**TOWN OF COVENTRY, RI
DEPARTMENT OF PLANNING & DEVELOPMENT**

STAFF REPORT

Project Name:	Village at Tiogue
Plan Type:	Comprehensive Permit / Major Land Development
Plan Review Phase:	Preliminary Plan
Owner/Applicant:	232 Realty Associates
Address:	Tiogue Avenue, Tiffany Road, East Shore Drive, & Minglewood Drive
Plat / Lot / Zone:	AP 32 Lots 149, 150, 151, & 153 Zone R-20 Lot Size 26.99 acres
Existing Use:	Vacant / Open Space
Proposed Use:	176 Single- and Multi-Family Units
Description:	Applicant proposes to develop 176 units comprised of a mix of single-family units and multi-family units on approximately 27 acres of land as a Comprehensive Permit. A minimum of 25% of the proposed units must be deed-restricted as affordable. Site access is proposed from Tiogue Avenue, Tiffany Road, East Shore Drive, and Minglewood Drive. Public water and sewer access to the development is anticipated.

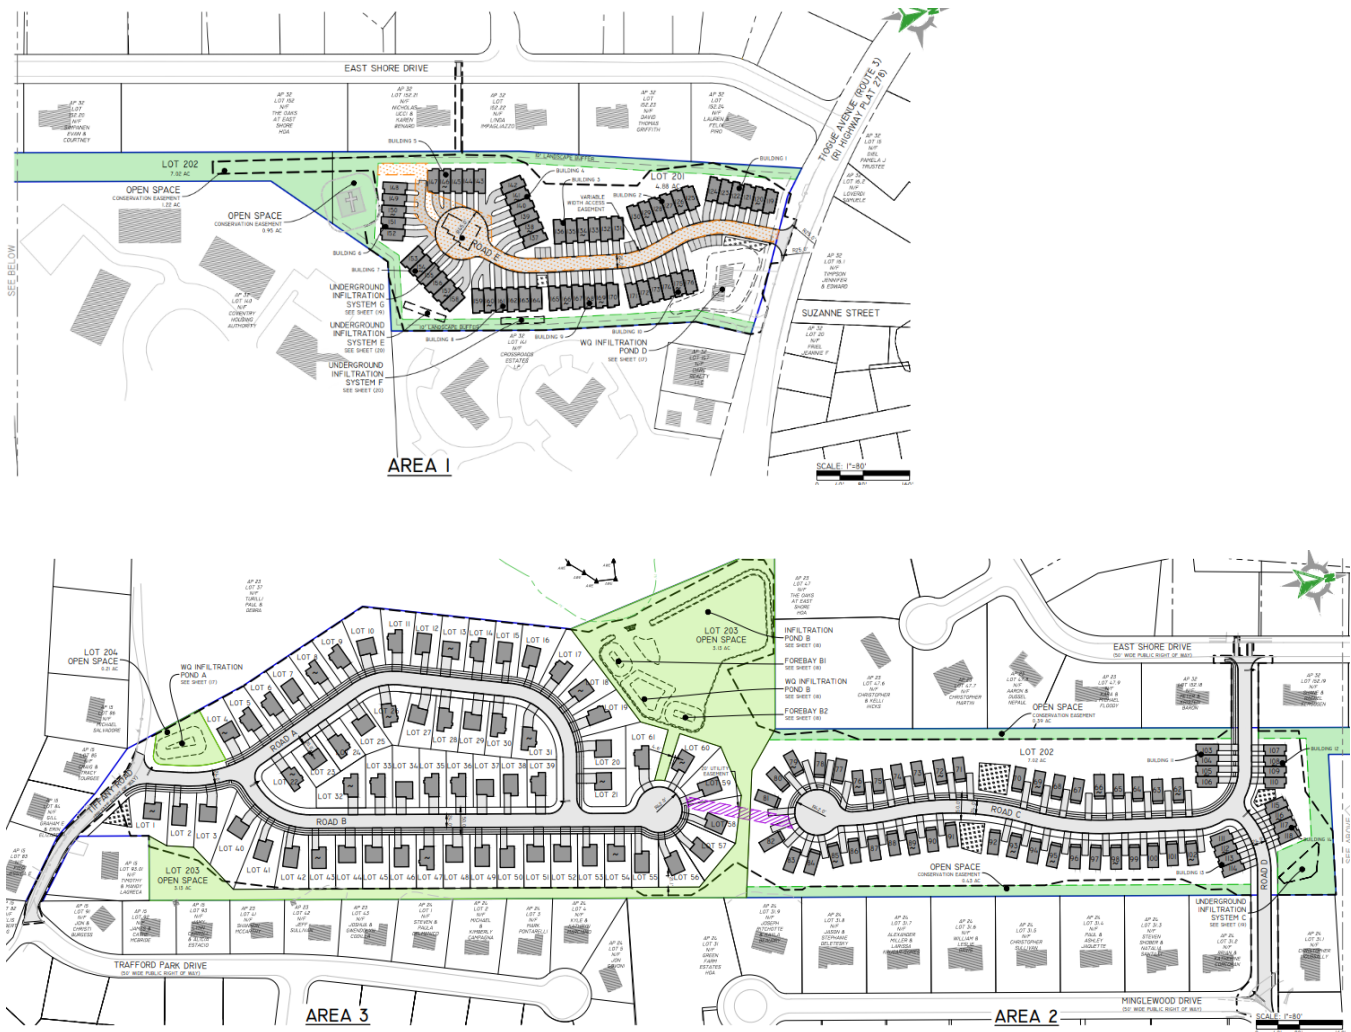
The proposed internal roadway design poses several issues for public safety and traffic circulation. The applicant proposes for the internal access roadways in Areas 2 and 3, labelled as Roads A, B, and C in the site plans, to culminate in a cul-de-sac. This layout leaves the single-family condominium units and attached multi-family units in Area 2 disconnected from the detached single-family homes in Area 3. At both the October and November TRC meetings, Engineering, Police, Fire, and DPW agreed that the lack of a through-road connection creates safety and access concerns for emergency responders. This is consistent with the Peer Review Report that states that the through-road connection will reduce the length of travel for emergency responders and everyday motorists travelling to New London Turnpike or Tiogue Avenue. In their response to the Peer Review, dated November 5, 2025, the applicant stated that they will agree to construct a through-road connection if the roadways are acceptable as public. Planning staff maintain that the ownership and maintenance of the internal roadways is a separate issue from roadway safety, and safety is of paramount concern.

The poor condition and narrow width of Tiffany Road also presents safety risks for emergency response and residents in the area, inclusive of the future residents of the proposed development. Consistent with the Peer Review Report, Planning staff recommends that the applicant make off-site improvements to the full length of Tiffany Road, from New London Turnpike to the site access road for Area 3 of the proposed development.

The "western" section of Tiffany Road, from the proposed site access road to the intersection with Old North Road should have pavement improvements and be widened to a minimum 20' unobstructed width. In their response to the Peer Review, the applicant has agreed to widen a portion of this section of Tiffany Road from the site access road to Trafford Park Drive to 22' with vegetation cleared for safe passage. For the other portion from Trafford Park Drive to Old North Road, the applicant stated that

Furthermore, the “eastern” section of Tiffany Road, from Old North Road to New London Turnpike, should be improved with new asphalt and widened to the maximum width possible to better accommodate emergency vehicles and future traffic demands. The road width should be 22’ at minimum for this section, or at least as wide as possible given the limited width of the Tiffany Road right-of-way. The applicant should also clear roadside vegetation to improve sight lines. In the response to the Peer Review, the applicant declined to extend improvements and widen the eastern section of Tiffany Road, citing the lack of “sufficient width for any widening,” the drop in topography, wetlands implications, and site constraints posed by private improvements, telephone poles, and mailboxes. The applicant stated that “the estimated traffic utilizing the one-way road is nominal.”
